High Energy Arcing Faults (HEAF) Test Program Comment Resolution

Nicholas Melly
Kenneth Hamburger
Gabriel Taylor P.E.
Mark Henry Salley P.E.
Office of Nuclear Regulatory Research
Division of Risk Analysis
July 9, 2019

Test Duration (cont.)

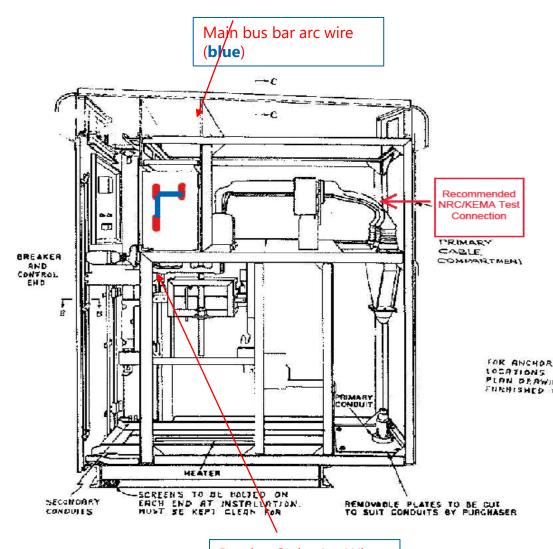
- Is an 8-second test realistic?
 - Operating Experience
 - Operating experience has identified multiple cases where prolonged duration events have occurred in both US and International OE
 - Medium Voltage prolonged duration events are consistent with generator-fed fault conditions and protection failure events
 - Low Voltage prolonged duration is plausible at currents which potentially fall between circuit protection set points

- Working Group activities
 - More realistic modeling
 - Modeling will NOT be one size fits all as currently in NUREG/CR-6850 EPRI 1011989
 - NRC/EPRI WG event tree/plant configuration and protection scheme taken into account
 - Low Voltage tests will be performed at 8 seconds under the acknowledgement that the results will only be applicable to specific configurations
 - The data from the low voltage tests will be investigated by the working group for the potential to inform medium voltage extended duration events beyond the test lab capability
